**Subject: Amended MHI's Response to US-APWR DCD RAI No. 694-5355 REVISION 1 (05.03.02)**

Amended Response to Request for Additional Information  
No. 694-5355 Revision 1

<b>RAI NO.:</b>	<b>NO. 694-5355 REVISION 1</b>
<b>SRP SECTION:</b>	<b>05.03.02 - PRESSURE-TEMPERATURE LIMITS, UPPER-SHELF ENERGY, AND PRESSURIZED THERMAL SHOCK</b>
<b>APPLICATION SECTION:</b>	<b>05.03.02, MUAP-09016</b>
<b>DATE OF RAI ISSUE:</b>	<b>02/10/2011</b>

**QUESTION NO.: RAI 05.03.02-11**

Figure A1-3 Generic P-T Limit Curves for Heatup

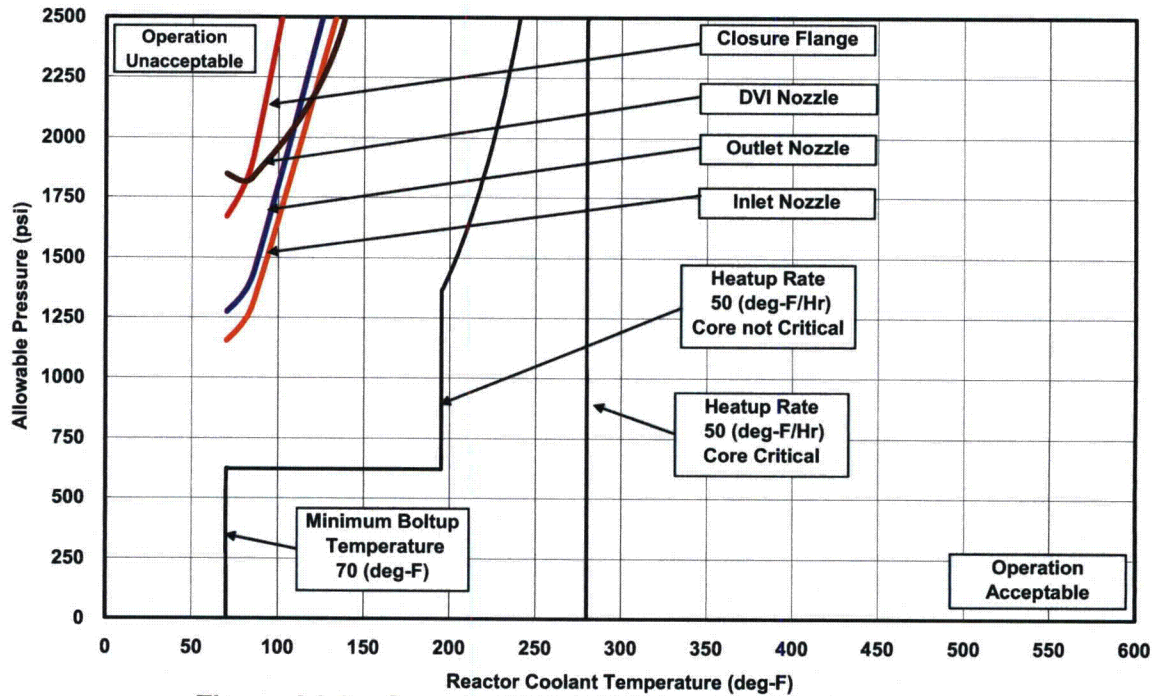
The US-APWR Pressure and Temperature Limits Report (Technical Report MUAP-09016) describes how the P-T limits for the US-APWR reactor vessel have been developed based on the evaluation of the beltline and closure flange regions. However, MUAP-09016 does not mention any consideration given to the vessel nozzles. Clarify how the analyses performed to develop the P-T limits for the US-APWR design has considered the entire reactor vessel, including the beltline, closure flange, and nozzle regions.

The fracture mechanics evaluation on the US-APWR reactor vessel is subsequently performed using stress analysis results. The fracture mechanics evaluation results including vessel nozzles are attached as Attachment-1 (Refer to Technical Report MUAP-09016 Revision 3), and shows the evaluation for the beltline and closure flange regions is conservative compared with those for vessel nozzles.
